City of Mississauga Department Comments

Date Finalized: 2023-01-18 File(s): A360.22

The applicant requests the Committee to approve a minor variance to allow an existing driveway with a driveway width of 8.712m (approx. 28.58ft) whereas By-law 0225-2007, as amended, permits a maximum driveway width of 6.00m (approx. 19.69ft) in this instance.

Property Address: 1735 Kentchester Pl

Appendix 1 – Transportation and Works Comments

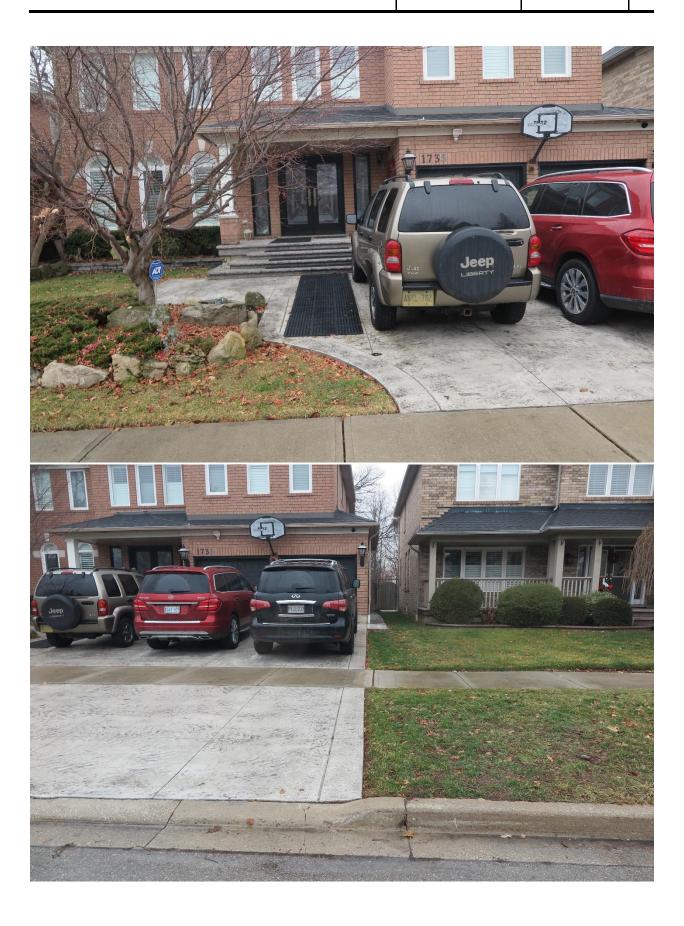
This department notes that with regard to the widened driveway within the municipal boulevard (the area between the municipal curb and property line) we would request that this area be reinstated with topsoil and sod should the application be modified to reflect a smaller driveway width within the subject property or if the application is not supported by the Committee.
